Subject: DA 2021/2416. 155 Pacific Rd Palm Beach

I am writing in relation to the proposed development at 155 Pacific Road, Palm Beach (DA 2021/2416).

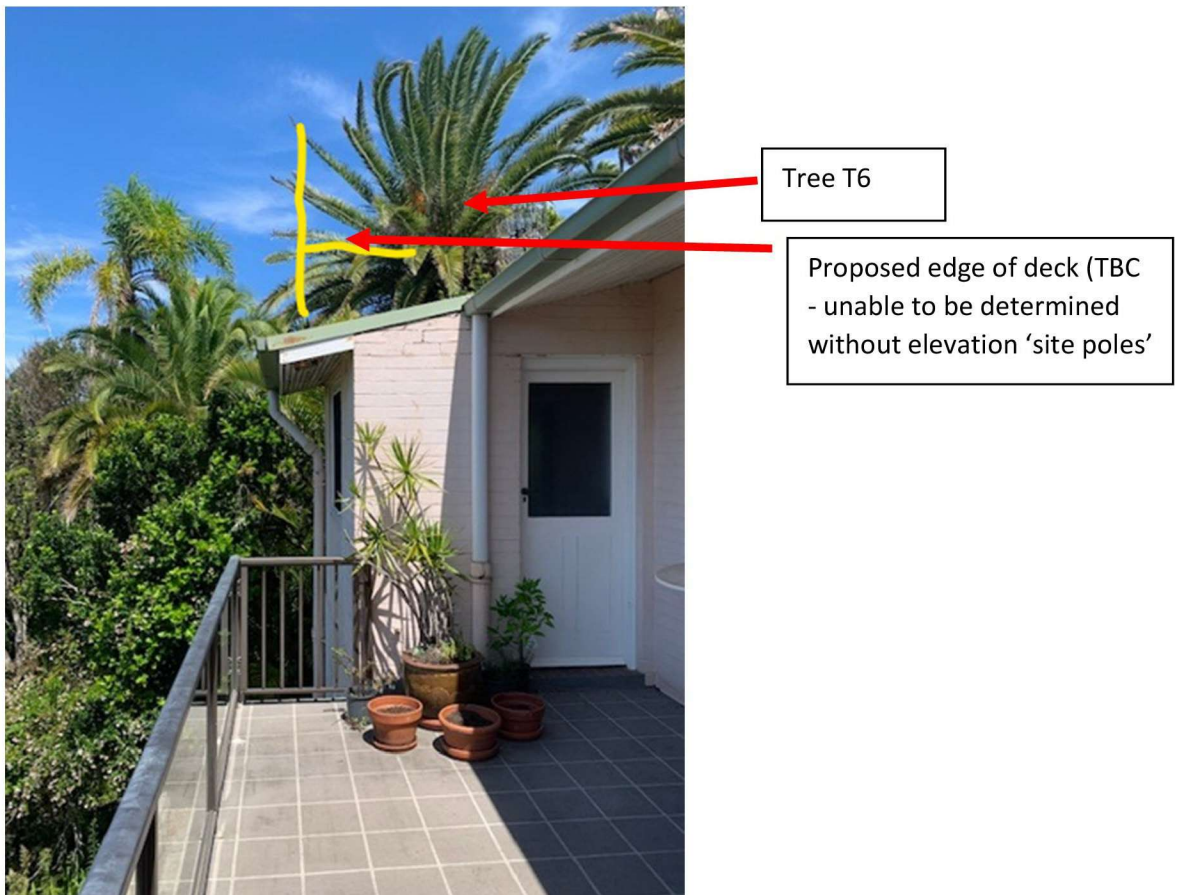
- III. Plan reference Section A-A shows the height of the Proposed Ground Floor to be above the height of our roof line, with the proposed deck touching the tree (T6) identified in the photo below, and extending past this. The deck will extend out to a line similar to our property and it is clear from the photo that persons standing on that deck will look over the edge of our house onto our deck space.

- IV. The photo below (refer next page for included photo) from our veranda shows our estimate of the location of the proposed deck against existing tree T6. Based on the height of the proposed ground floor, and the plan to push the building to a point touching tree T6, this deck, and the adjacent proposed window (W17), will look over the top of our property and will be able to look directly down on to our existing veranda diminishing our private usage and enjoyment of our property.
